RE: Agreement No. 1655  
Traffic Impact Study Services  
**Task No. 1 Subtask 14A – King Property – Outparcels**

McCormick Taylor has completed its review of the Traffic Operational Analysis (TOA) for the King Property – Outparcels development prepared by Davis, Bowen & Friedel, Inc. (DBF), dated November 2015. This review was assigned as Task Number 1 (Subtask 14A). DBF prepared the report in a manner generally consistent with DelDOT's *Development Coordination Manual*.

*King Property – Outparcels*

**PROPOSED INTERSECTION:  
US ROUTE 13 AND NORTH SITE ACCESS /RELOCATED POSITIVE OUTCOMES DRIVEWAY  
SKETCH PLAN & INITIAL LANE CONFIGURATIONS**

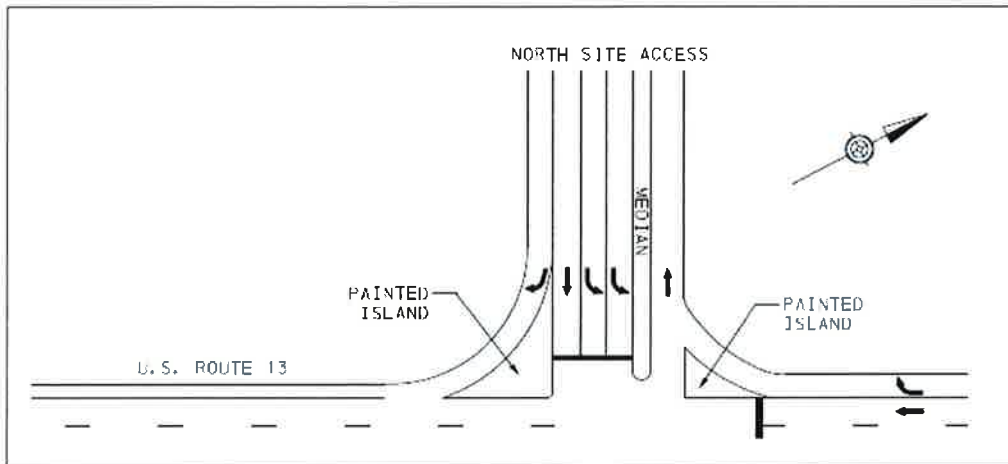
3. The developer should construct the proposed North Site Access on US Route 13, approximately 1,300 feet north of Voshells Mill Road. The location shall be consistent with the location where the proposed Camden Bypass will intersect US Route 13.

As part of this site access intersection construction, the existing driveway for the Positive Outcomes Charter School on the east side of US Route 13, which intersects US Route 13 at a median crossover approximately 975 feet north of Voshells Mill Road, will be modified to restrict exiting movements. The main Positive Outcomes driveway will be relocated to intersect US Route 13 directly across from the proposed North Site Access. The proposed initial configuration of the new intersection is shown in the table below and in the sketch plan that follows on Page 7. Additional lanes and longer lanes will be needed in the future to accommodate the Camden Bypass and the US Route 13 Widening projects.

Approach	Current Configuration	Proposed Configuration
Northbound US Route 13	Two through lanes	One left turn lane and two through lanes
Southbound US Route 13	Two through lanes	One left-turn lane, two through lanes and one right-turn lane
Eastbound North Site Access	Approach does not exist	Two left-turn lanes, one through lane and one right-turn lane
Westbound Relocated Positive Outcomes Driveway	Approach does not exist	One left-turn lane and one shared through/right-turn lane

The developer should coordinate with DeIDOT's Subdivision Section to determine other design details for the proposed intersection and all intersecting roads, as the design must accommodate both the Camden Bypass project and DeIDOT's *HEP KC, US 13 Lochmeath Way to Puncheon Run Connector Project*, which would add a third through lane each way on US Route 13 through this intersection. Specific to the North Site Access driveway (western leg of this proposed intersection), a comparison of the interim condition that should be constructed by the developer vs. the ultimate condition that will be needed to accommodate the two aforementioned projects is provided on Page 8.

Initial recommended minimum turn-lane lengths (excluding tapers) of the separate turn lanes are listed below. The developer should coordinate with DeIDOT's Subdivision Section to determine final turn-lane lengths during the site plan review process.

Approach	Left-Turn Lane(s)	Right-Turn Lane
Northbound US Route 13	260 feet *	N/A
Southbound US Route 13	235 feet *	305 feet **
Eastbound North Site Access	115 feet *	50 feet *
Westbound Relocated Positive Outcomes Driveway	90 feet *	N/A

**Comparison of Interim Condition vs. Ultimate Condition for North Site Access Driveway  
(as referenced in Item No. 3 above)**

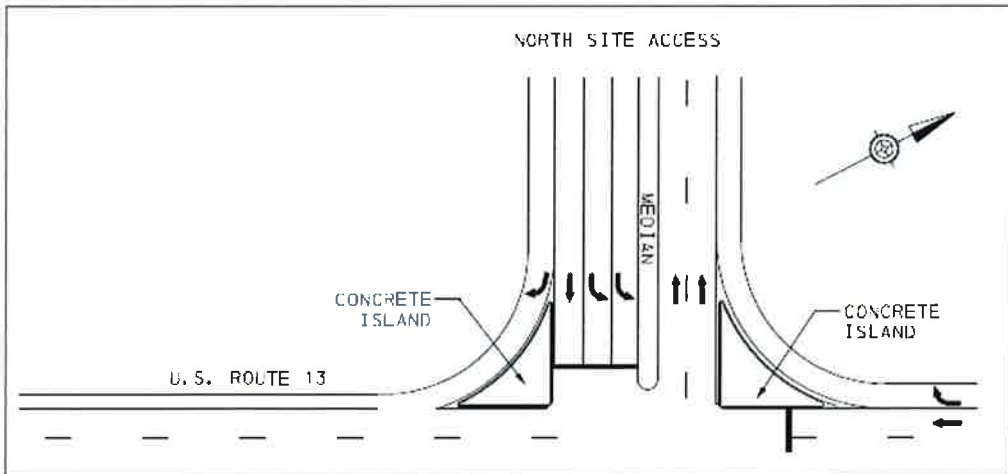
The following lane widths are required on the North Site Access driveway (west leg of the US Route 13 intersection) for the ultimate condition needed to accommodate the two aforementioned projects, for a total cross-section width of 93 feet. This ultimate condition is shown on the bottom of Page 8.

Direction of Road	Proposed Configuration and Lane Widths for Ultimate Condition
Eastbound North Site Access	Two 11’ left-turn lanes One 11’ through lane One 5’ bike lane One 11’ right-turn lane
Median	4’ median with 1’ offset on both sides
Westbound North Site Access	Two 11’ receiving lanes (for northbound US 13 dual lefts) One 5’ bike lane One 11’ separate receiving lane (for southbound US 13 right turns)

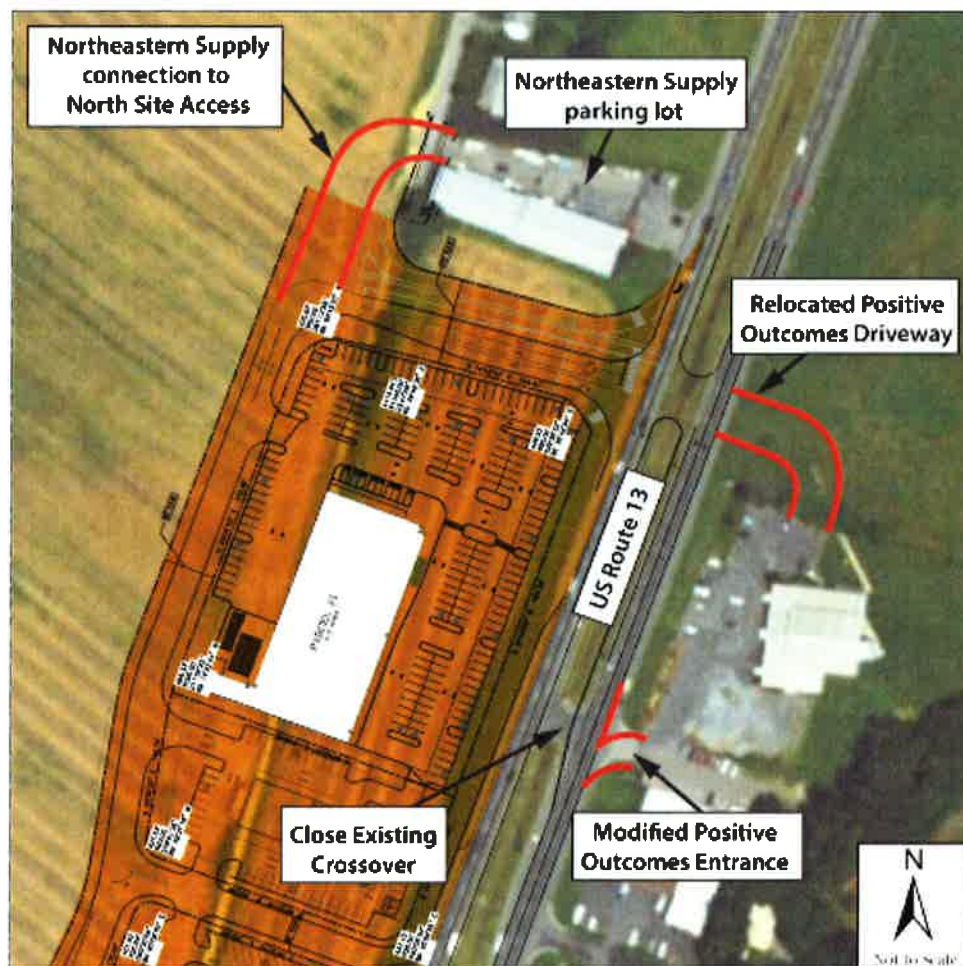
- The developer should close the existing US Route 13 median crossover and the associated left-turn/u-turn lanes located approximately 975 feet north of Voshells Mill Road. The paved area for this crossover and the turn lanes should be removed and replaced with grass median, consistent with the adjacent median. The existing driveway that serves the Positive Outcomes Charter School on the east side of US Route 13 at this crossover should be restricted to right turns in, with no exit, as described above in Item No. 3.

For clarification, the figure provided immediately below illustrates a concept plan of many of the elements described in Item Nos. 3 and 5, including the North Site Access location, the Relocated Positive Outcomes Driveway, the Northeastern Supply alternate access, the closure of the existing median crossover, and the modified existing Positive Outcomes Driveway (rights-in only).
